## QDV-1000 Digital Voice Module

This Technical Information Update applies to QDV-1000 Digital Voice Modules that were purchased between September 1, 2008 and April 23, 2009.

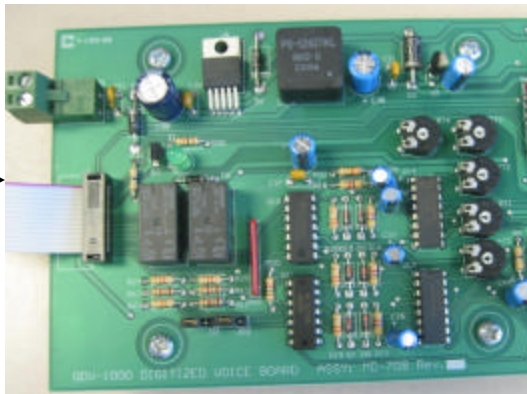
A small batch of QDV-1000 Digital Voice Modules that were manufactured with date **code 38/08** were assembled with the wrong ribbon cable orientation therefore they will not function as intended and will damage the QIF-5000 interface module if used. It is recommended that the QDV-1000 be replaced.

Please use the diagram below to identify the incorrect ribbon cable assembly.

### Wrong Orientation

**Red Stripe**

### Correct Orientation

**Red Stripe**

We have identified the problem with the automated test method where the ribbon was not being properly tested; the test procedures have been altered to prevent this problem from reoccurring. If the QDV-1000 has the incorrect ribbon cable assembled, it is recommended that Customer Service be contacted and the QDV-1000 will be replaced under warranty.

All new builds and those currently in stock have been upgraded with the correct ribbon cable assembly.
